SUNDRY NOTICES AND REPORTS ON WELLS
*Do not use this form for proposals to drill or to re-enter an
abandoned well. Use Form 3160-3 (APD) for such proposals.*

8. Well Name and No. NE Square Lake Premier Unit #31

9. API Well No. 30-015-25943

Permanent Abandonment of Federal Wells
Conditions of Approval (LPC Habitat)

DATE: Oct. 10, 2019
BY: MKHS
WELL: #31
STATE: NM

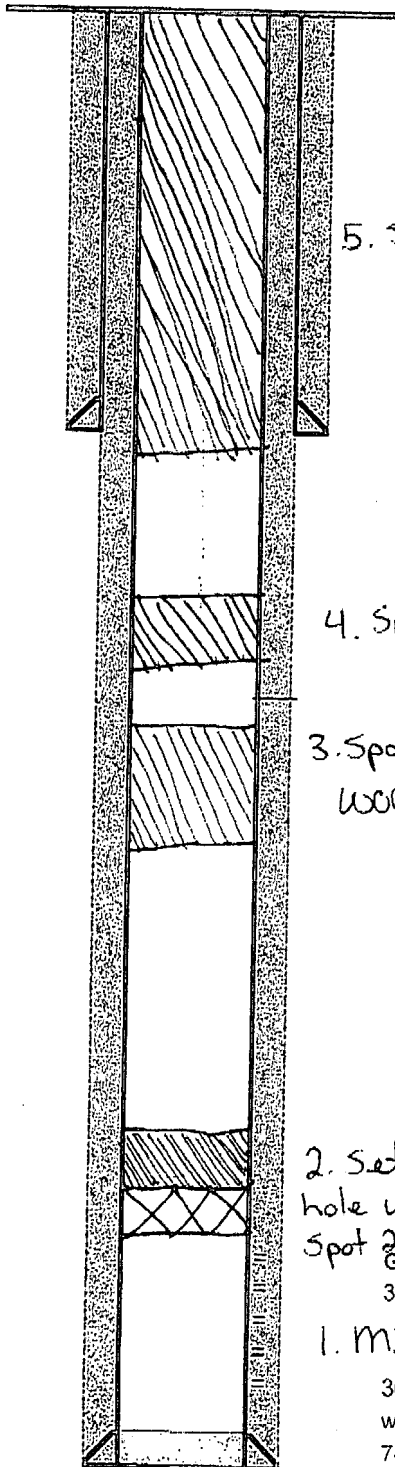
GC 1/20/20
Accepted for record - NMOC
